**CONGRUENT SOFTWARE, INC.**  
**3998 Whittle Avenue**  
**Oakland, CA 94602**  
**(510) 531-5472**

FROM: Peter Johansson  
 TO: T10 SBP-2 *ad hoc* Working Group  
 DATE: February 8, 1997  
 RE: Transport Status for SBP-2

The proposal below is intended to clarify and enhance the definition of *sbp\_status* in SBP-2 Revision 2. For some time there has been general agreement that the status definition was not yet complete. Here is a starting point for discussion. Modifications to the existing SBP-2 Revision 2 clause are shown by change bars.

**Figure 28 – Status block format**

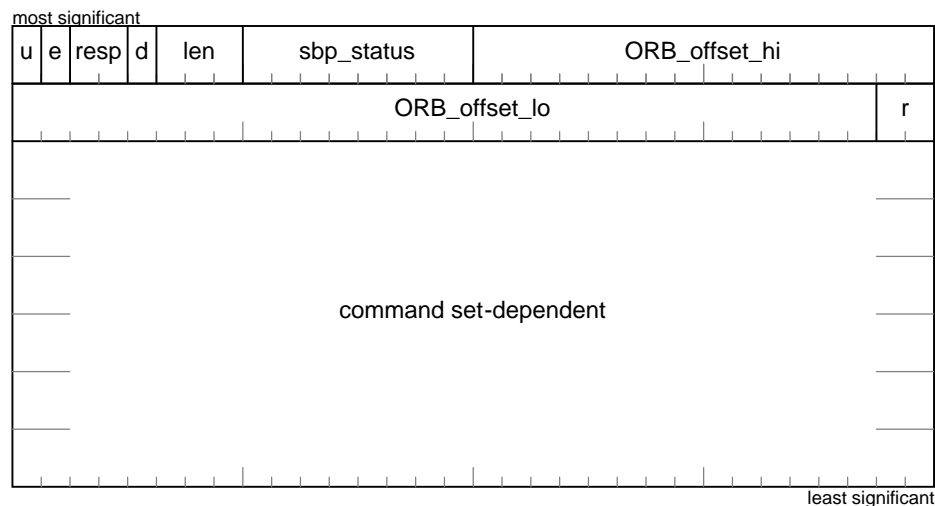
The target shall store a minimum of eight bytes of status information and may store up to the entire 32 bytes defined above so long as the amount of data stored is an integral number of quadlets. [A truncated status block shall be interpreted as if the omitted fields had been stored as zeros.](#) The target shall use a single Serial Bus block write transaction to store the status block at the *status\_FIFO* address.

[The \*dead\* bit \(abbreviated as \*d\* in the figure above\) shall indicate whether or not the target fetch agent transitioned to the dead state upon storing the status block. When \*dead\* is zero, the reported status has not affected the state of the fetch agent. If the \*dead\* bit is set to one, the fetch agent transitioned to the dead state as a consequence of the error condition reported by the status block.](#)

The *sbp\_status* field provides additional information that qualifies the response status in *resp*. The meanings assigned to *sbp\_status* [vary according to the value of \*resp\* and are described below](#) **are specified by the table below.**

[When \*resp\* is equal to zero, REQUEST COMPLETE, the possible values for \*sbp\\_status\* are specified by the table below. Any value not enumerated is reserved for future standardization.](#)
